# **Design review – ProtoDUNE-SP Purity Monitor Connections**

Jianming Bian (UCI)  
Andrew Renshaw (UH)  
09/26/2017

# Line Diagram: Inside Cryostat

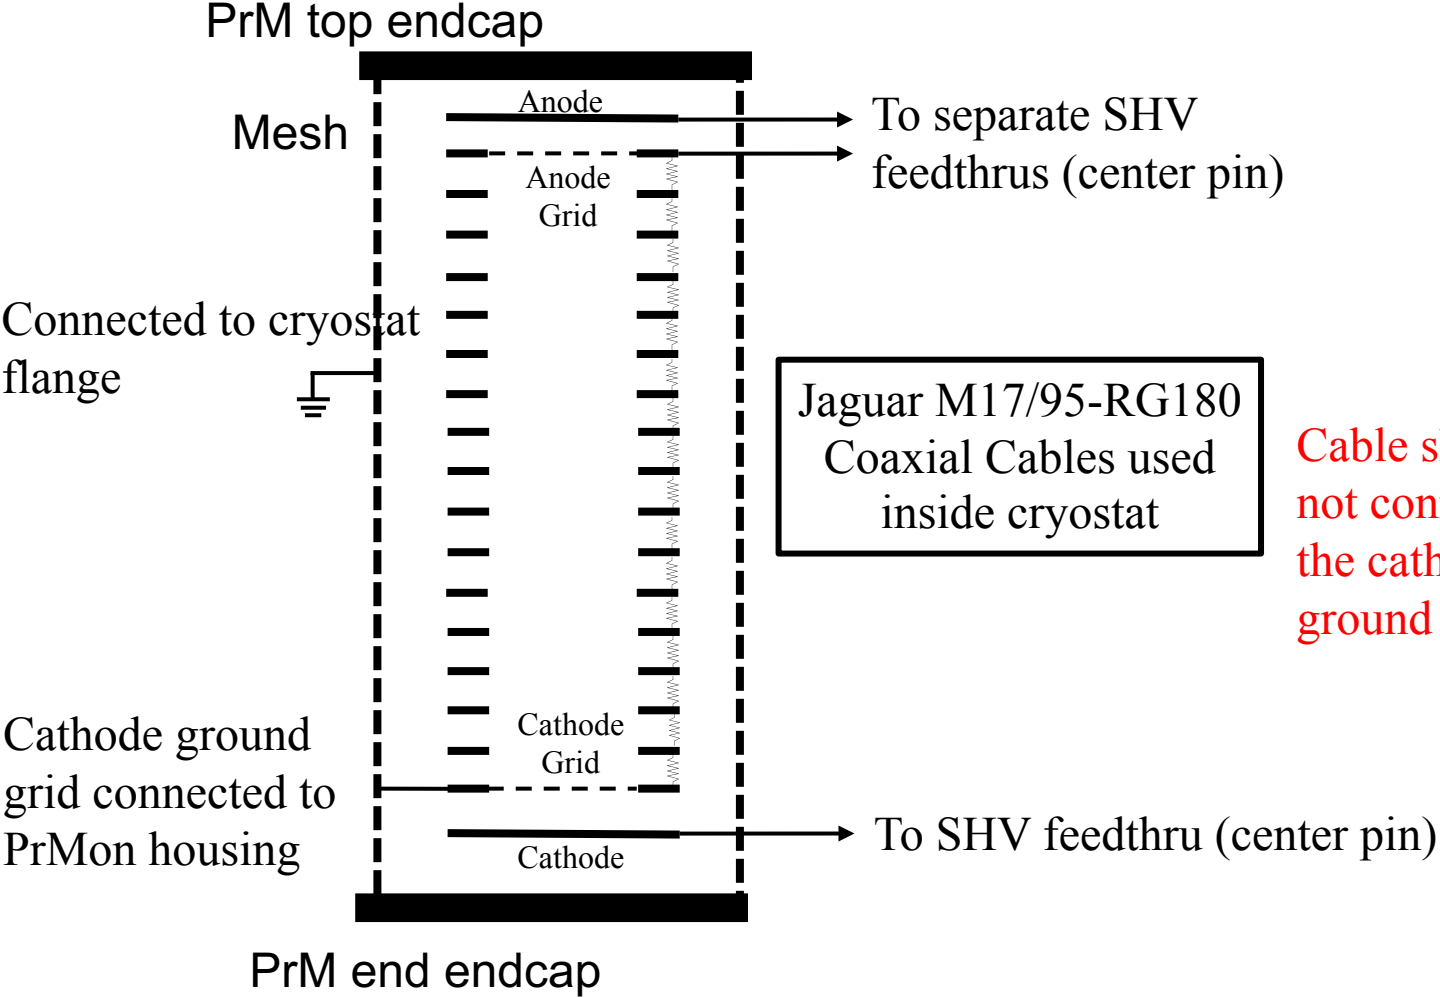
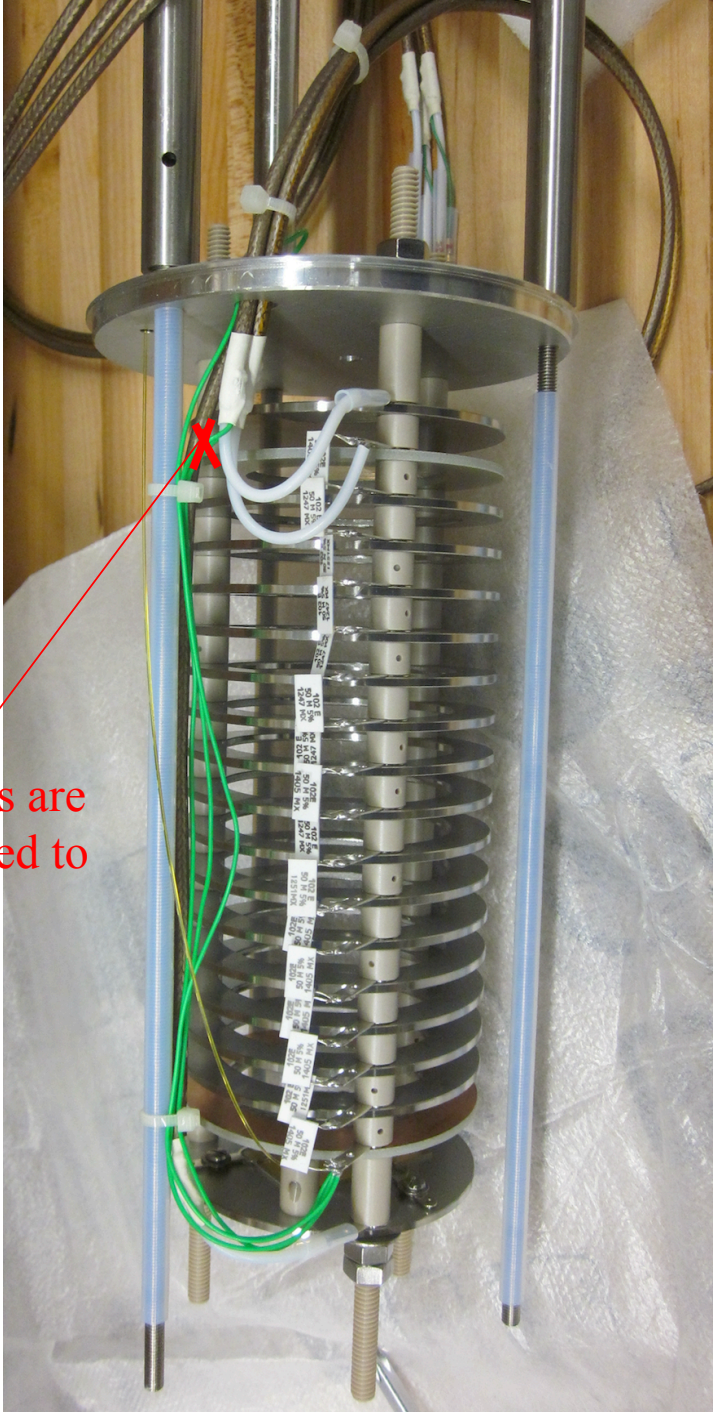
Q3. Are all system and subsystem ground connections sufficiently well understood and documented? Are there any critical single point failures?

- We have reviewed our ground connections and have modified the grounding design according to the review, see DUNE-doc-4115.
- The electronic connections are parallel for the three purity monitors → No SPOF
- PrM system doesn't rely on any other sub-system, and only communicates with slow control → No SPOF

Cable sheids are not connected to the cathode ground grid
